Re:- 104 R.S.1, Ramswami Qrt.

PLAN OF PROPOSED BUILDING ON PLOT NO 104 R.S.1

PLAN NO. 128

Case No. P/C 27/39

SITE PLAN.
SCALE 20' TO 1" INCH.

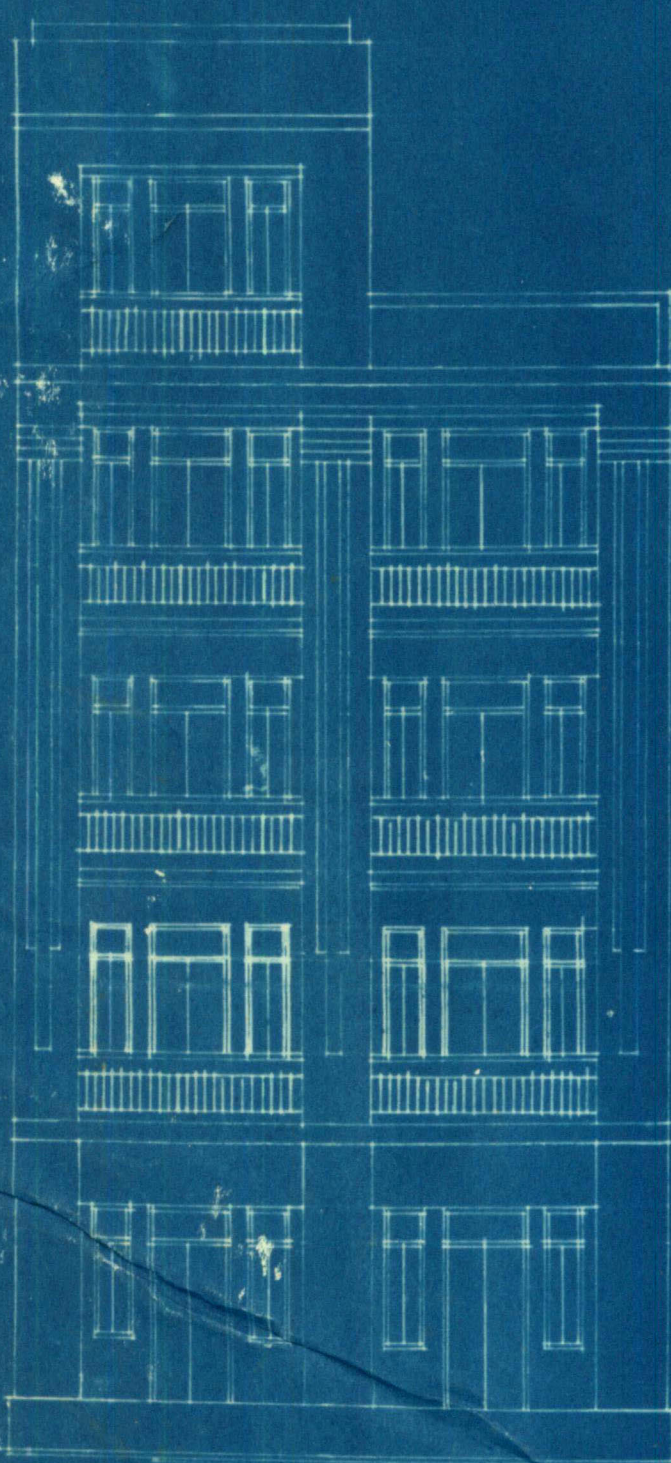
Area of the plot to be stated

AREA OF PLOT 244 SQ.YDS.

GROUND FLOOR PLAN.

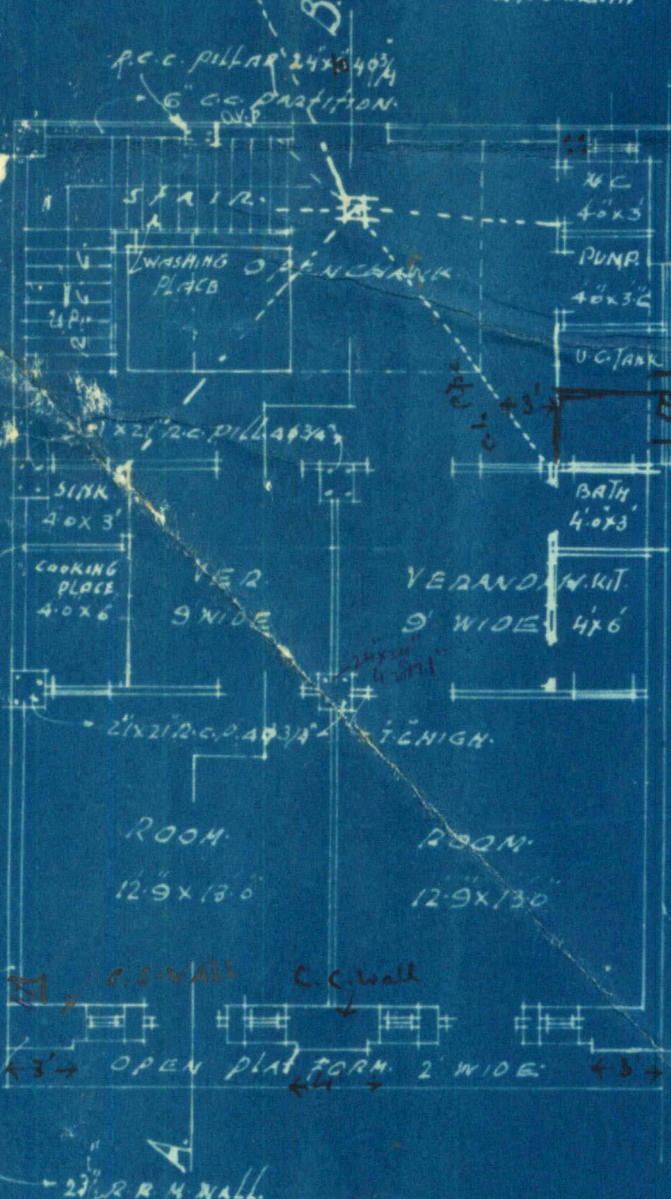
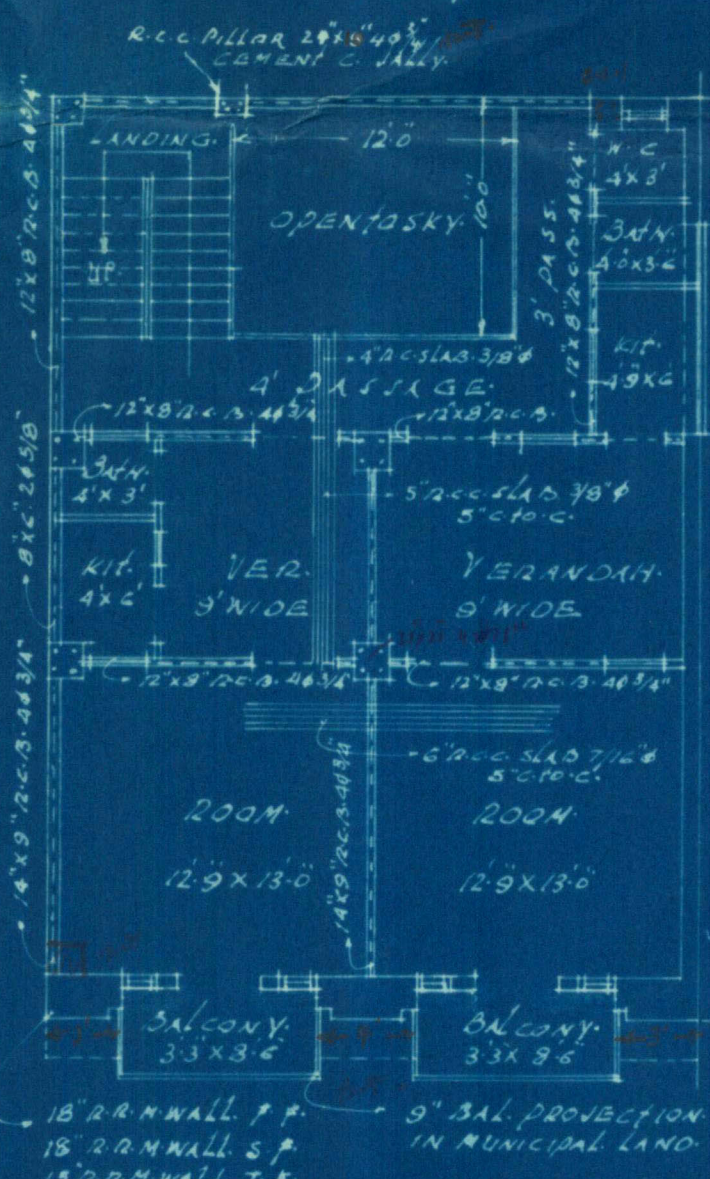
1. Outline of the U.G. tank to be shown 5' away from drainage lines & 2' away from adjoining plot.
2. O.H. tank should have 2 set back from adjoining owner's wall.

TO BE CONNECTED WITH R.C. DRAIN
